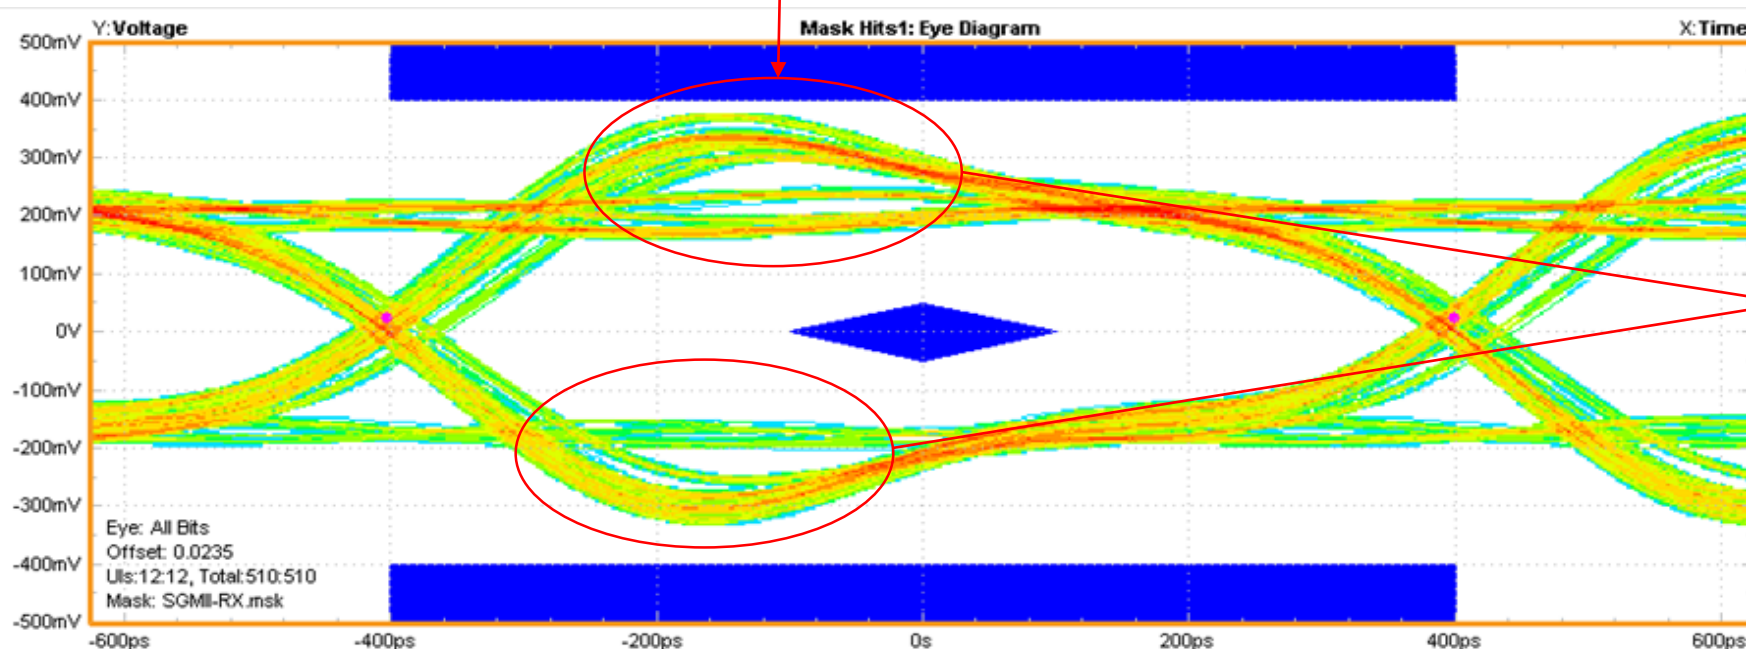
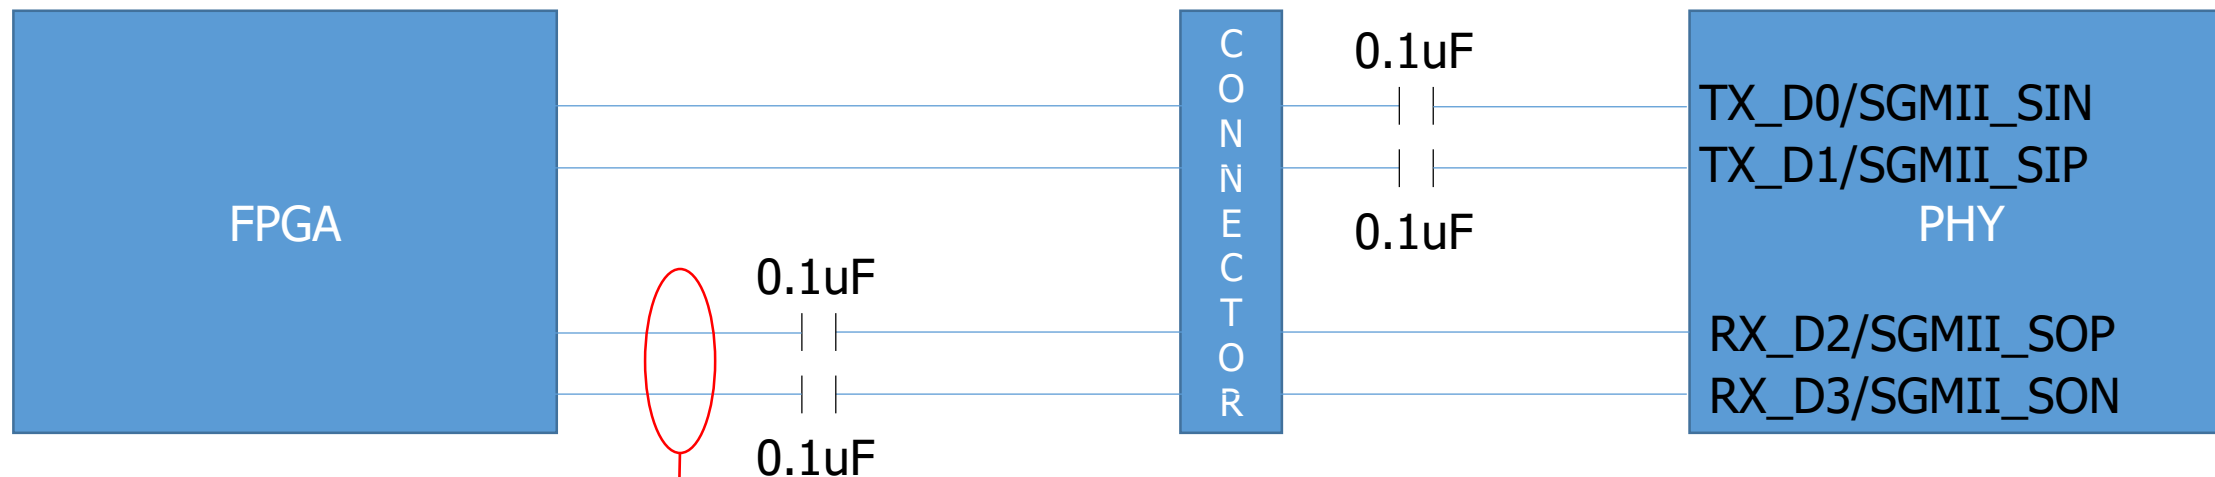
The customer would like to suppress these undershoot and overshoot. Do you have any ideas using register setting which is relation to SGMII? It seems that there is no way which is to use register setting.

So, as the method of hardware
-To remove the connector
-To insert damping resistance
Is our recognition correct?
